Network Working Group  
Request for Comments: 175  
NIC 7074

Comments on "Socket Conventions Reconsidered"  
-----

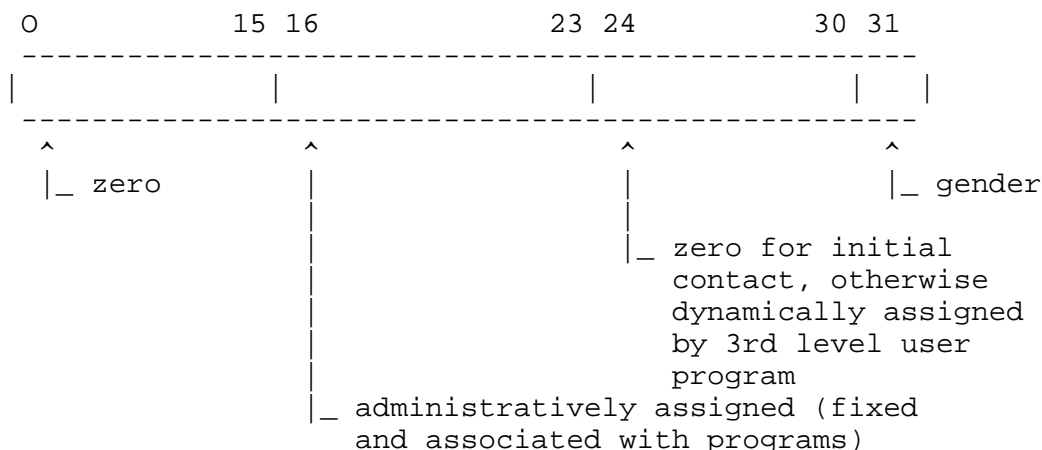
Our current use of socket names is diagrammed below.

(NOTE: This scheme corresponds exactly with both UCSB and UCLA/CCN conventions).
